Service Bulletin

No. : MZ06-037

Model: SR7400

Subject: When the CPU (IC28) is replaced, a firmware rewrite is required.

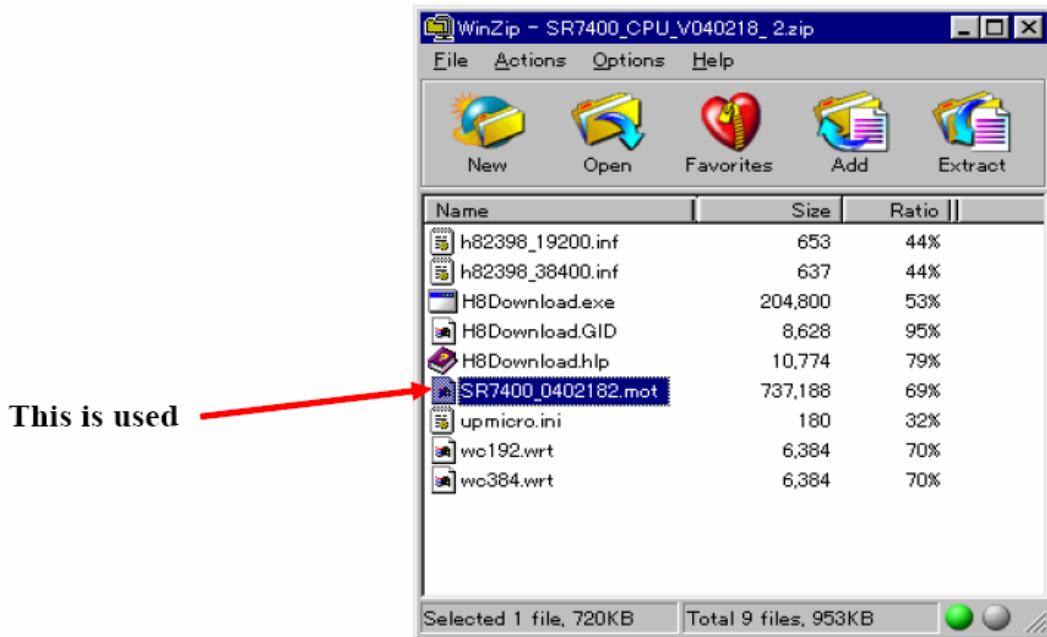
Symptom: 1. A rewrite is required when the CPU (IC28) is replaced during an SR7400 repair. SR5400, SR6400 and SR7400 CPU's (IC28) are all common, but the firmware is different. The firmware for SR5400/SR6400 is already written in the replacement parts CPU (IC28), a rewrite for SR7400 firmware is required to overwrite the incorrect firmware version.
2. Rewrite of firmware is necessary. Otherwise the unit won't operate after replacing the CPU.

Solution: 1. When CPU (IC28) is replaced, rewrite software for SR7400
2. The rewrite software use the file name "SR7400_CPU_V040218_2.zip ". Version is V040218_2. Double-click "SR7400_0402182.mot ", start the program. Please refer to the service manual SR7400 page 61 to 62 for the procedure. "12.UPDATE FIRMWARE Download Firmware for CPU (Mode 2)"
